**STAFF REPORT:** 9/10/25 REGULAR MEETING

**APPLICATION NUMBER:** HDC2025-00544

**ADDRESS:** 97 ARDEN PARK BOULEVARD

**SCOPE:** PRIMARY ELEVATION WORK, REBUILD PORCHES AT FRONT, REAR, AND SIDE\* (WORK STARTED WITHOUT PERMIT), RESTORE/REPLACE WINDOWS, REPAIR/REPAINT TRIM, REPOINT MASONRY

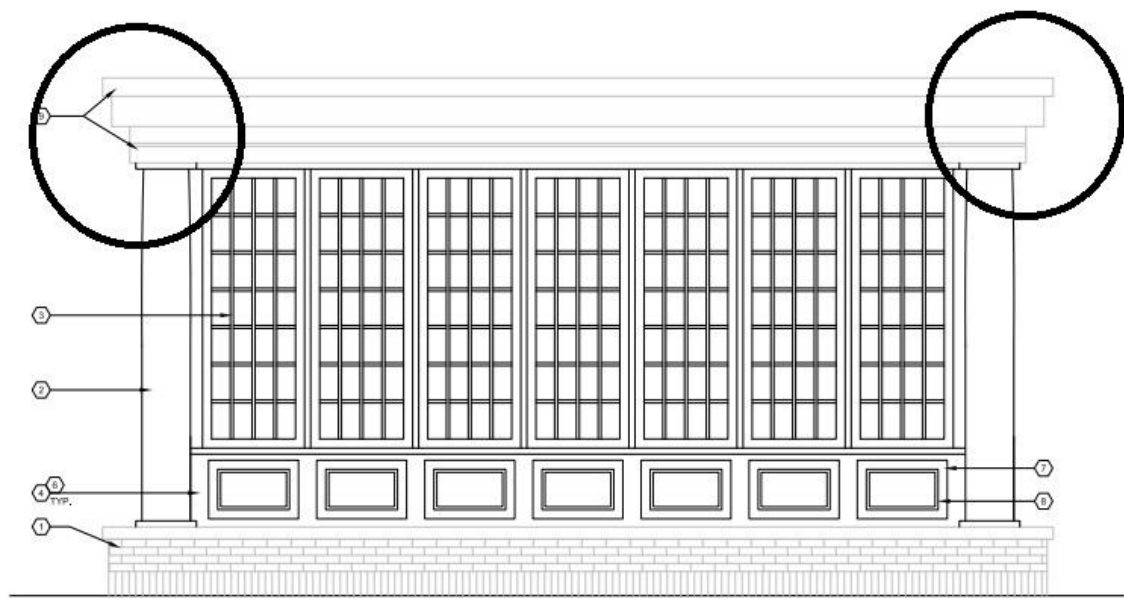
- All columns were removed without approval and without documentation that their condition was beyond repair.
- West porch to be enclosed: The existing wood trim, soffit, and fascia elements of the west porch have been built but not to plan. The entablature has many layered cornices and the resulting proportions are not compatible with the historic house. The entablature should be rebuilt as per the submitted plan to match the entablature on the front portico. The west porch should not be more detailed than the historic front portico to avoid detracting from it.

*Detail from applicant's materials. At top is the new entablature on the west porch that will rest on the column when installed. On bottom is the historic entablature on the front of the house. The detailing and proportions are different when they should be the same, based on the historic (front) feature.*

*Comparing the front historic feature (top) with the newly built feature on the west porch (bottom), using photos from the applicant's materials. The historic cornice projects out over the frieze and architrave. It seems that the modern construction stacks trim to progress from the frieze to the roof.*

- The west enclosed porch's entablature must match that of the front portico. Applicant will provide detailed drawings of the entablatures of both the historic front portico and the new proposed west porch to staff for review and approval.

*From applicant's materials, proposed rear porch railing.*

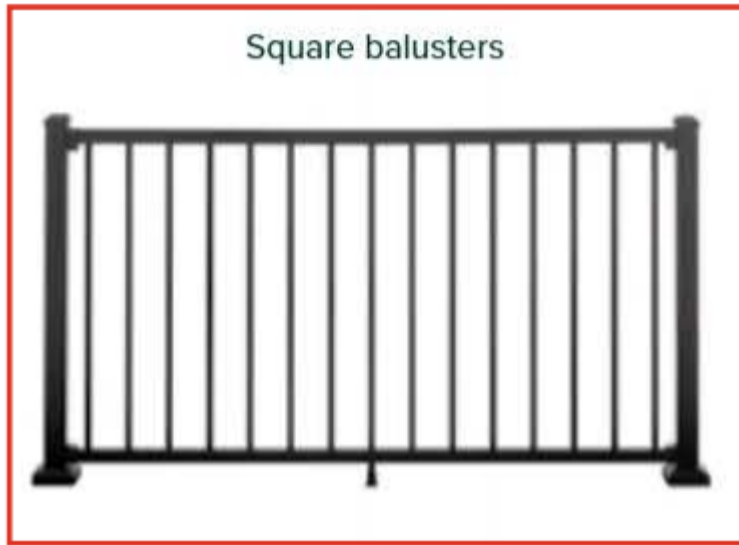
- Rear porch: Wood deck and stairs are proposed to be pressure-treated wood. Staff suggests the condition that all pressure-treated wood must be painted when cured. Unpainted/clear-coated wood is not a typical historic condition.
- Rear porch: A contemporary aluminum rail (see below) is proposed. In staff's opinion, using a black contemporary rail on the rear porch is incompatible with the house's historic character. It is staff's opinion that a simple wood railing painted to match the column on this small rear porch, perhaps lower than proposed and with a simple booster rail to increase the height for safety, would be more compatible with the historic house than the proposed rail. If a 36" black rail is desired in the hope that it disappears visually, perhaps a railing could be sourced that has a more traditional appearance and proportions than

the very contemporary and spindly rail proposed. Staff's recommendation is that the architect submit a rear porch railing to staff for final approval.

- On the rear porch, any pressure-treated wood used will be painted when cured.
- For the rear porch, a different rail will be submitted for staff review and approval.
